Remarks

The Office Action mailed November 2, 2004 has been carefully reviewed and the foregoing amendment has been made in consequence thereof.

IN THE DRAWINGS

FIG. 7

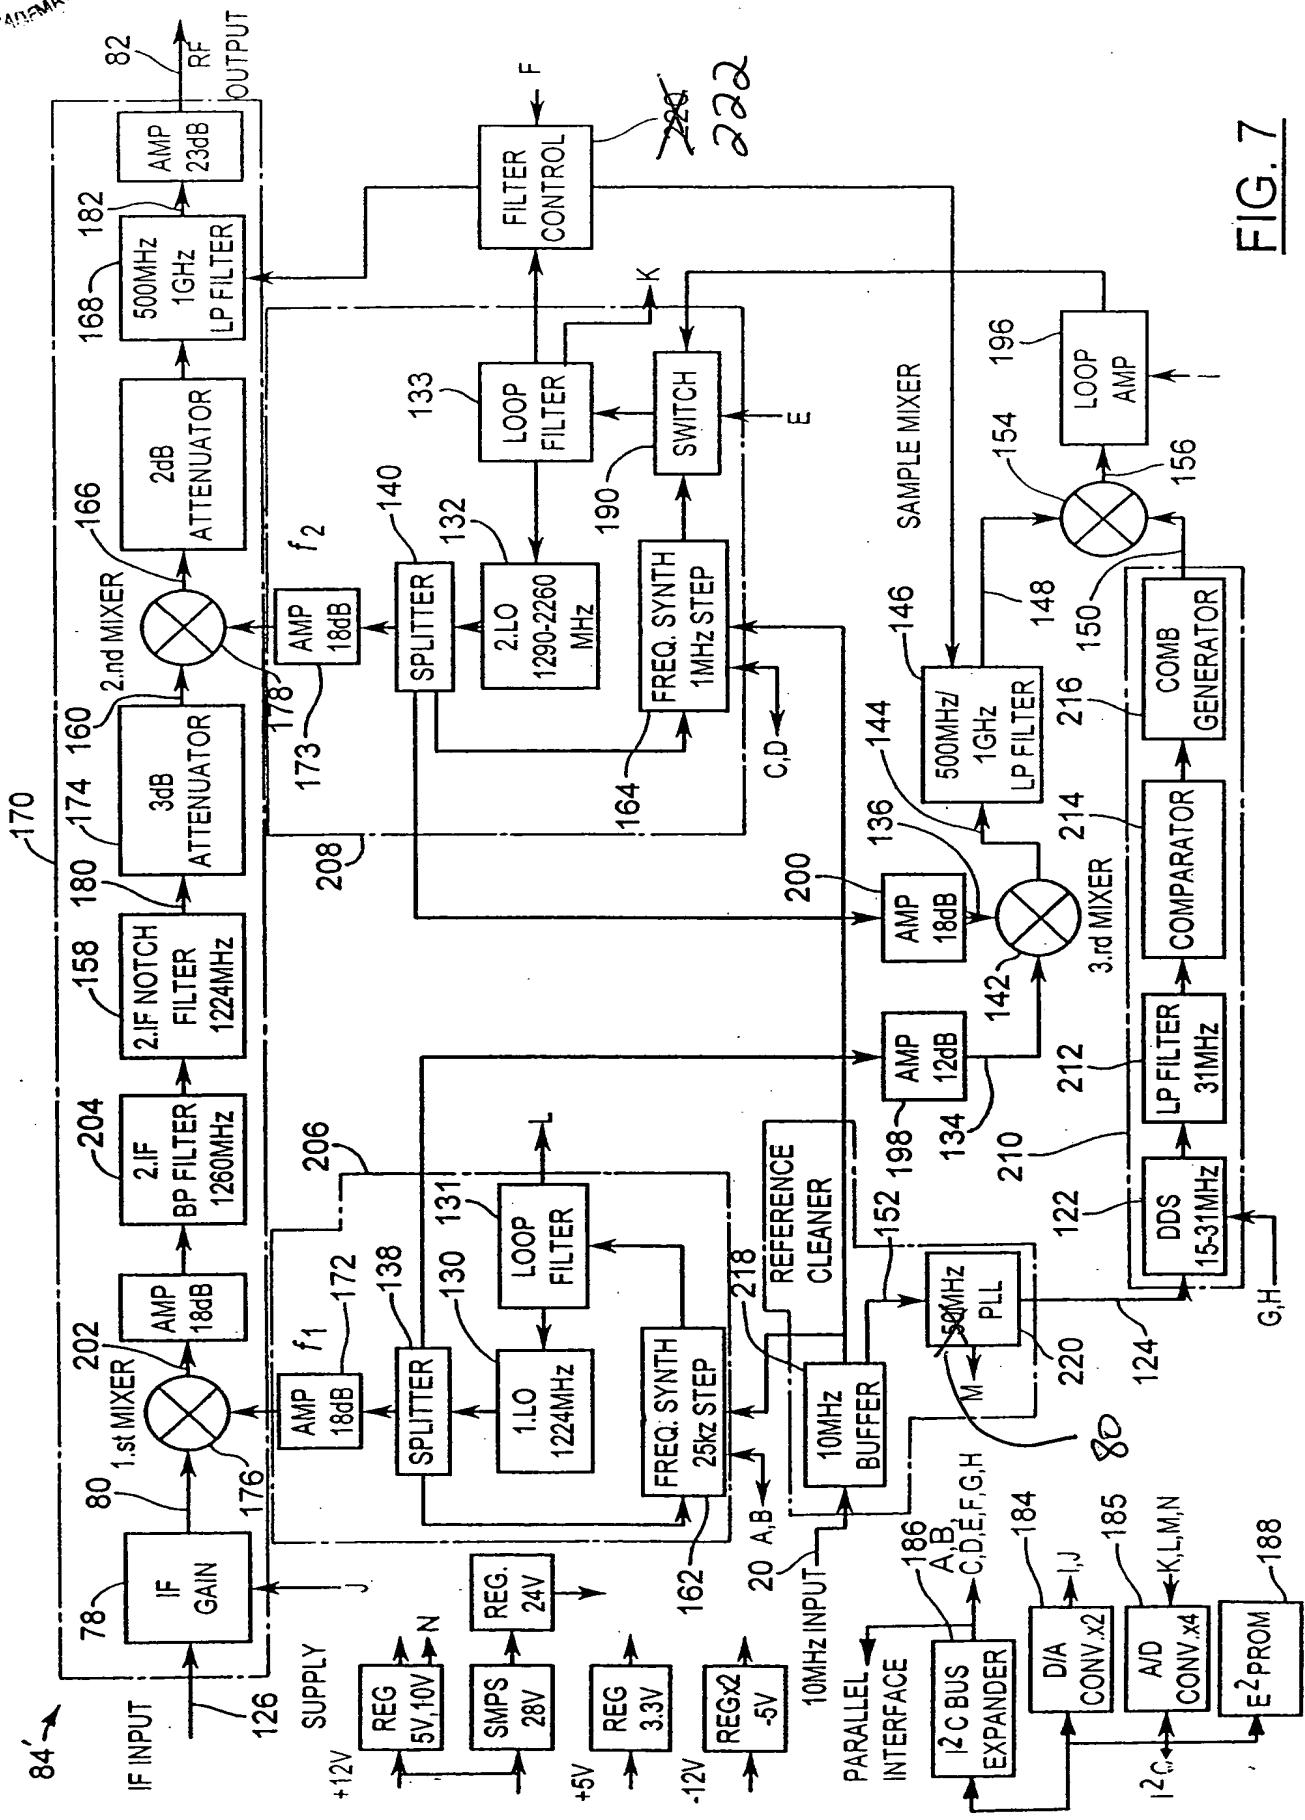
The objections to the drawings are respectfully traversed. A drawing change for Figure 7, including an annotated sheet and a replacement sheet, is submitted herewith. In addition, the specification has been amended to address issues noted in the Office Action relating to the reference numerals used in the drawings. For the reasons set forth above, Applicant requests that the objections to the drawings be withdrawn.

Applicant respectfully requests approval of the following drawing change. Specifically, Figure 7 has been amended to correctly indicate reference numerals 220 and 222 as utilized in the specification. Applicant submits replacement drawing sheets incorporating the change to Figure 7. Also submitted herewith is an annotated Figure 7, reflecting the requested changes in red ink. No new matter has been added to the application.
